87 ST. JOHN STREET

APPLICATION FOR PERMIT

SUBJECT: Addition to News Body Co.
81 St. John Street, Portland, Maine.

In checking the application for permit for construction of a one story addition on side of garage at the above named location we find that while there is curbing along the street frontage of the property, the sidewalk, if any, consists only of dirt. Section 1 of the Sidewalk Ordinance recently adopted by the City Council requires that where an existing building is enlarged and a paved sidewalk as well as curbing does not exist along the front of the property, one shall be provided. You should therefore consult the City Traffic Engineer, Samuel Conner, whose office is in the quarters of the Public Works Department in City Hall, as to what may be necessary to comply with requirements of the Sidewalk Ordinance.

WET SPRINKLER SYSTEM ORDINARY HAZARD

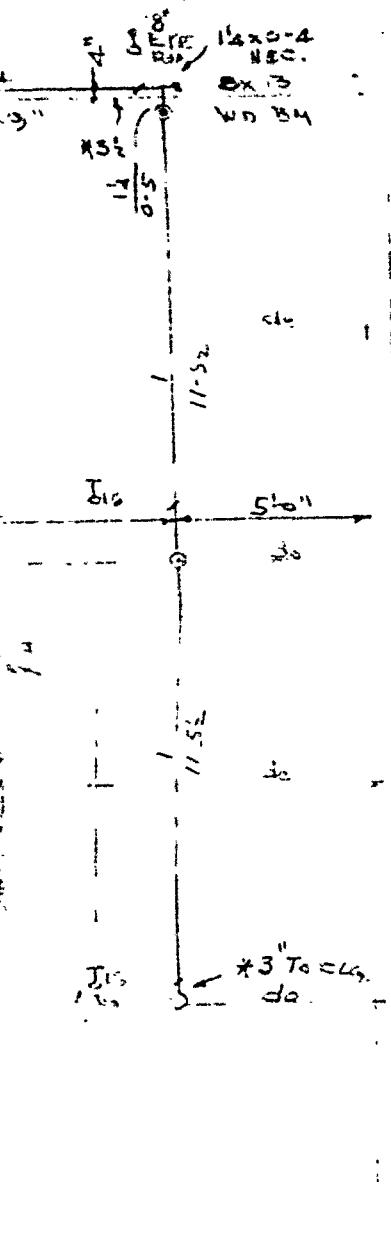
3-4" NEW LOCATION 34" DIA N

RECUT TO SUIT
EXISTING 2" DROP.
INSTALL NEW TEE
2-34-2

APPROVED
NEW ENGLAND FIRE INS. RATING ASS'N.
89 BROAD ST., BOSTON, MASS.
IMPROVED RISKS DEPT.
Approved for Construction as shown
with *Corrections*
